DATE: 12/7/23

SUBJECT: ADDENDUM NO. 2 TO THE BIDDING DOCUMENTS FOR

CDB-818-010-103  
REPAIR AND REPLACE ROOFS – PHASE 3  
WESTERN ILLINOIS UNIVERSITY  
ILLINOIS BOARD OF HIGHER EDUCATION  
MACOMB, MCDONOUGH COUNTY, ILLINOIS

ROOF DETAILS		PROJECT NO.
REPAIR AND REPLACE ROOFS - PHASE III		818-010-103
ILLINOIS BOARD OF HIGHER EDUCATION		DATE 11/6/2023
WESTERN ILLINOIS UNIVERSITY		SHEET NO. A502
MACOMB, McDONOUGH COUNTY		OF 13 SHEETS

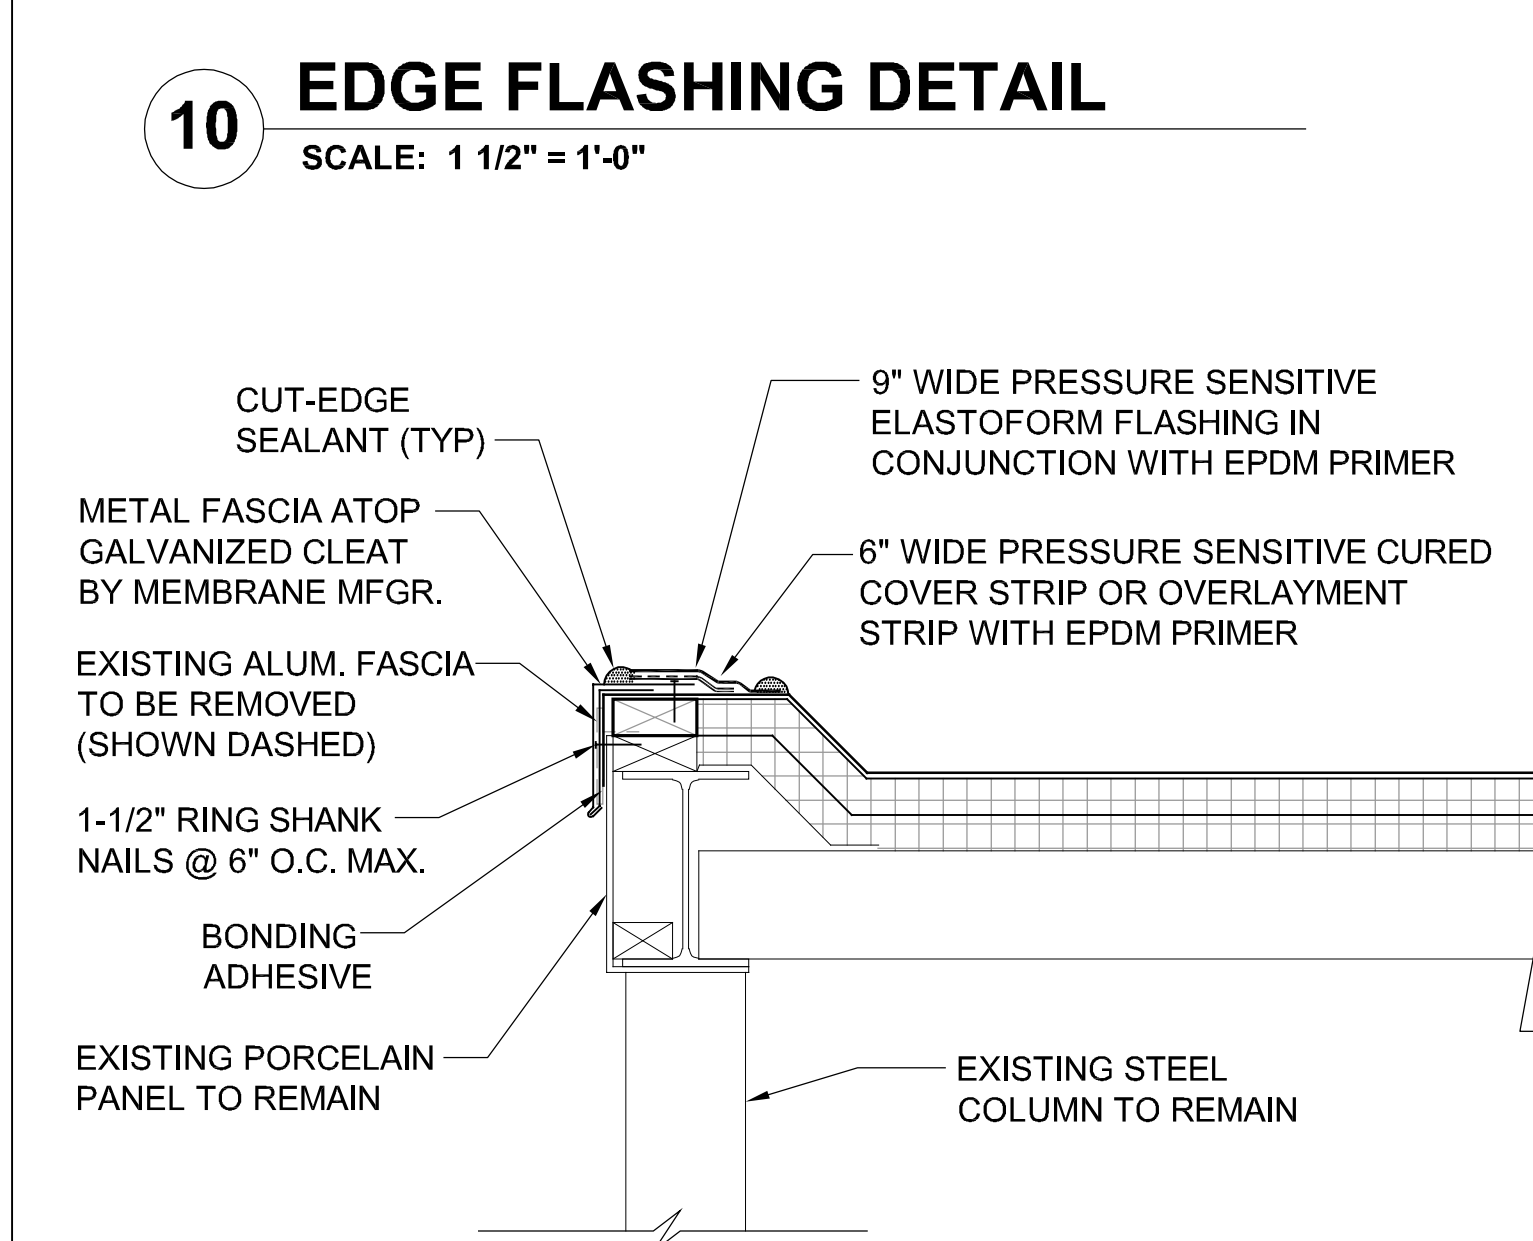
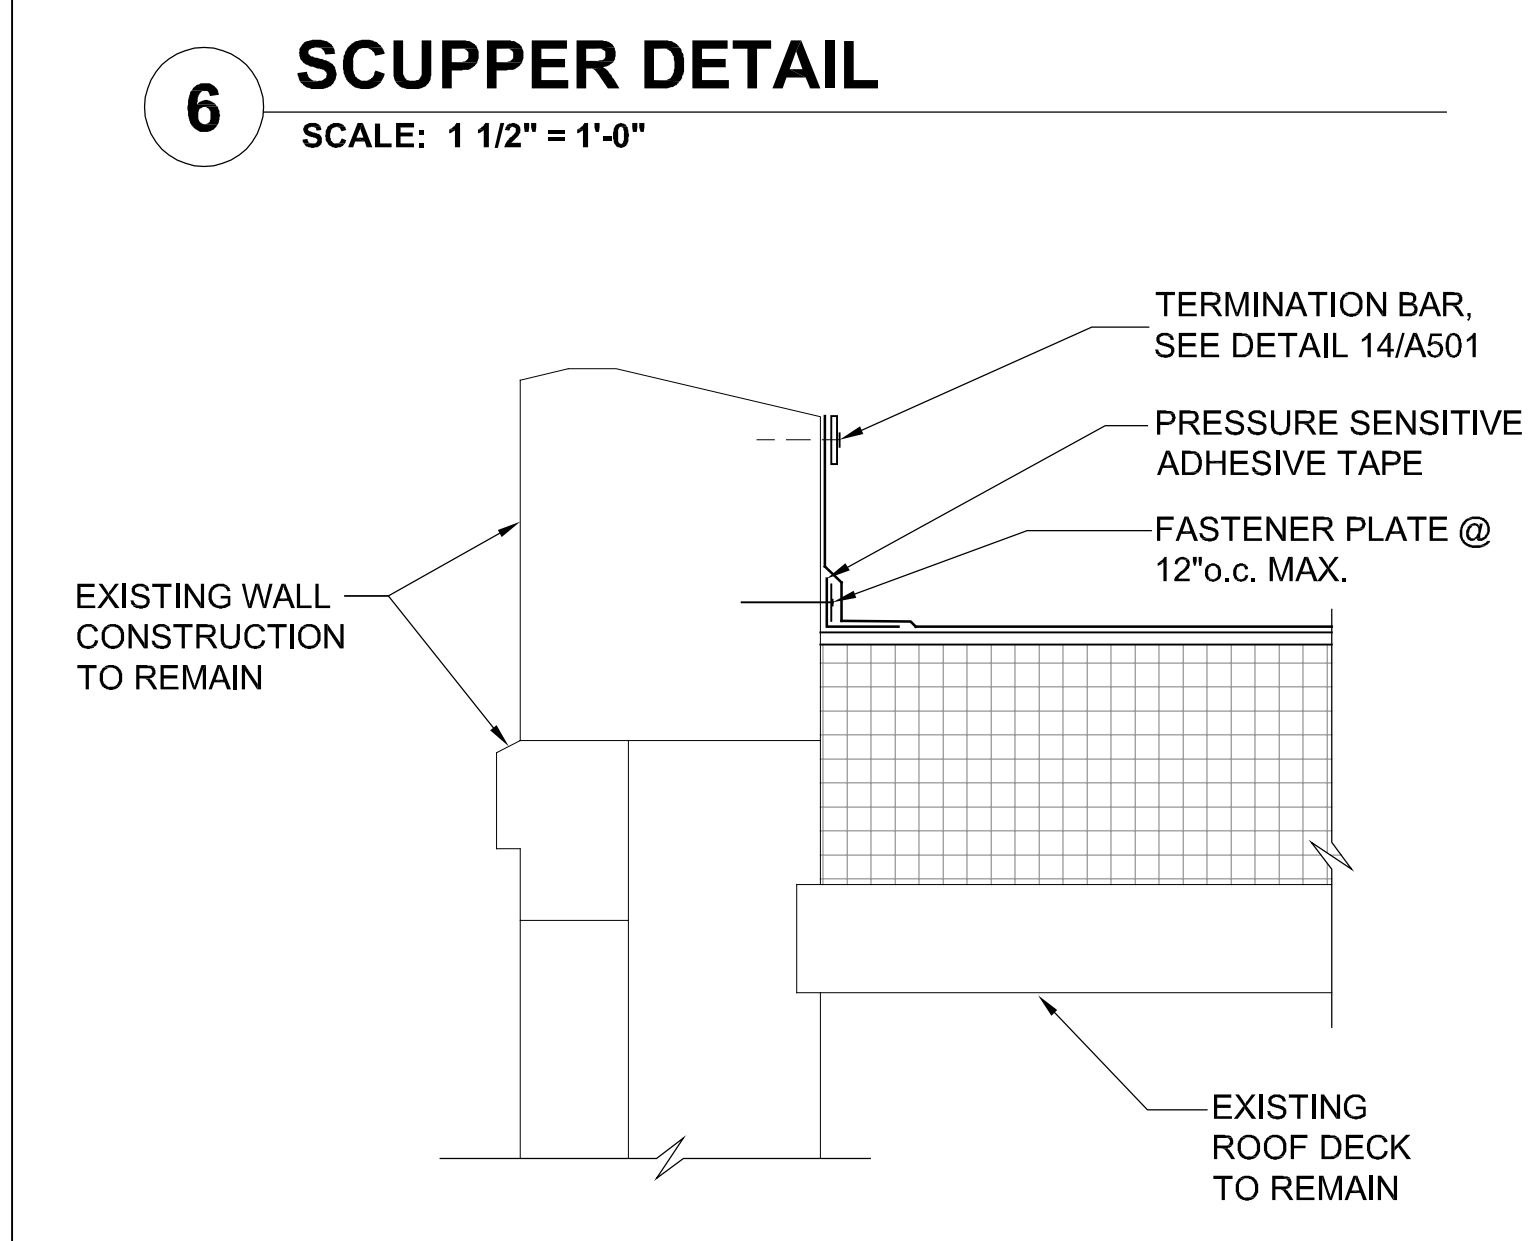
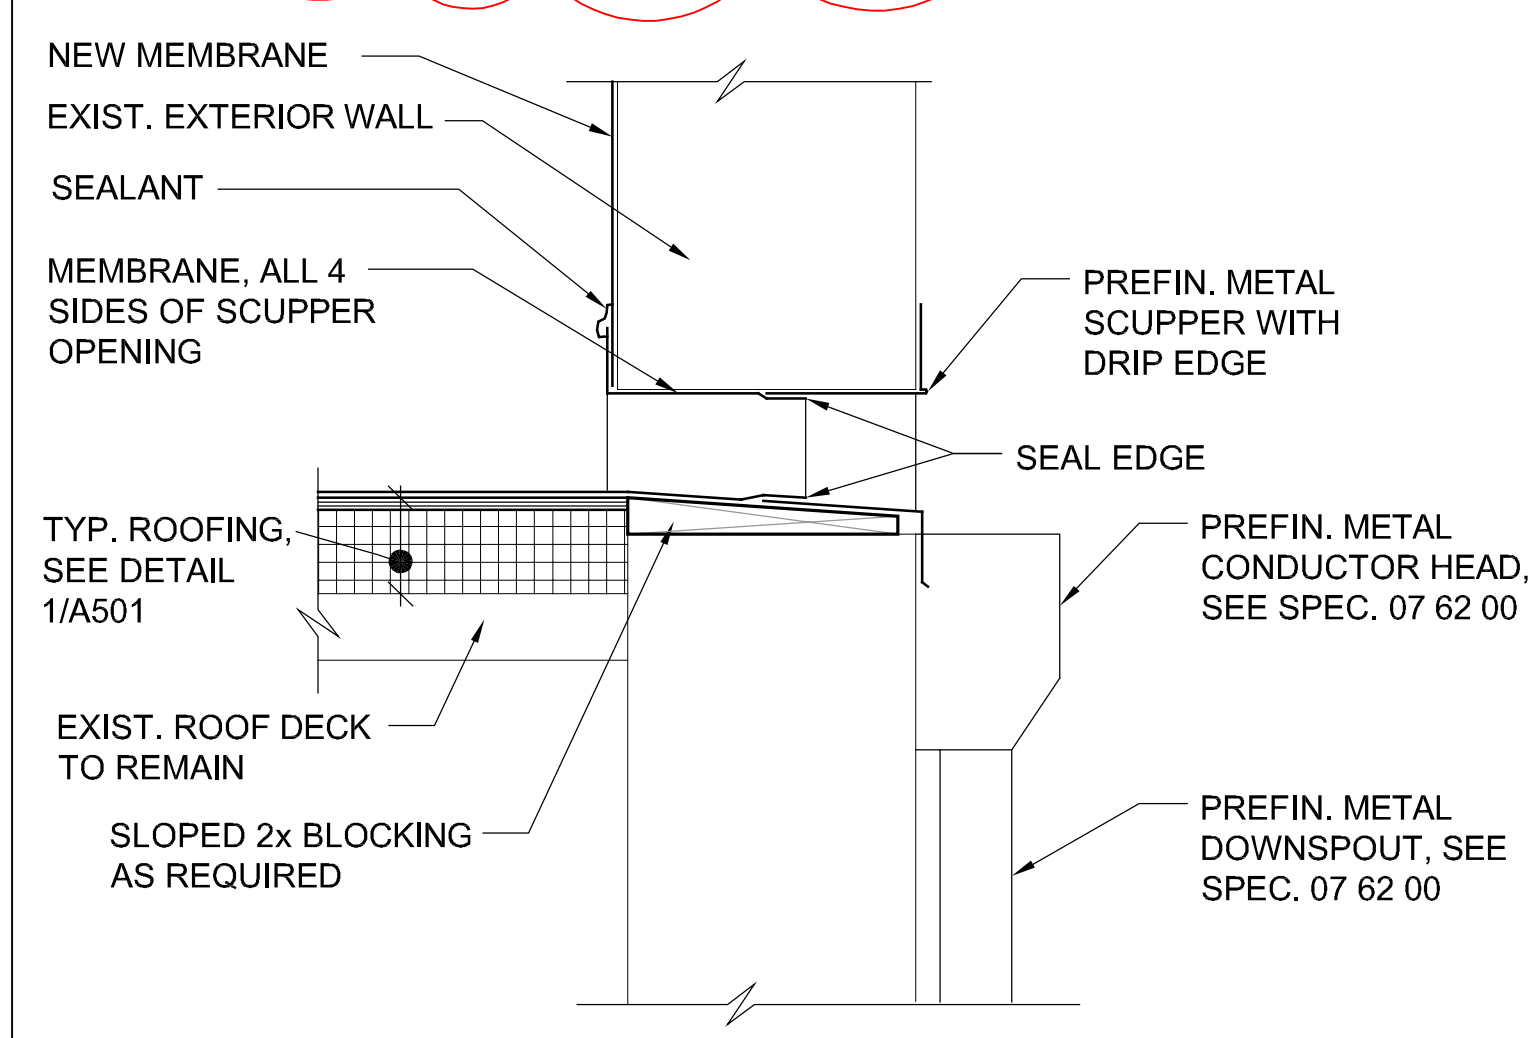
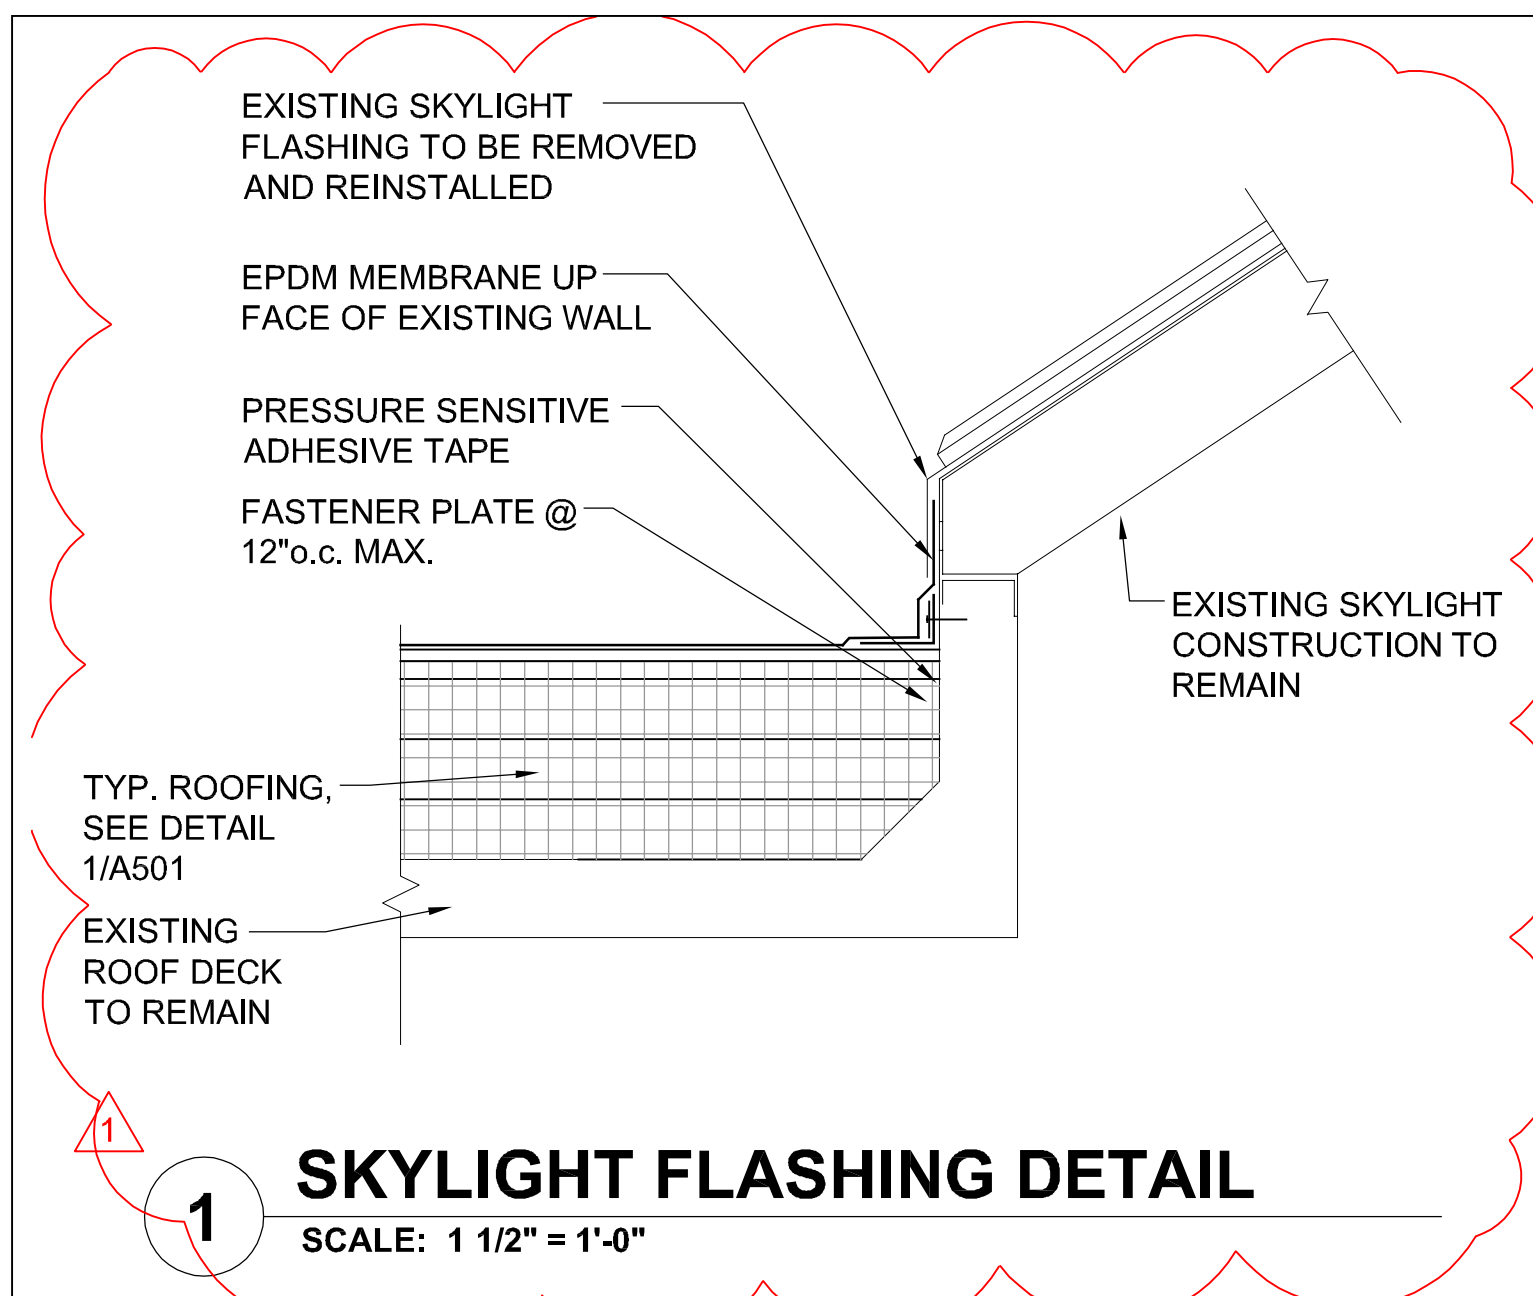
9. SHEET A502: Detail 1 has been revised to show the proper flashing and insulation thickness.
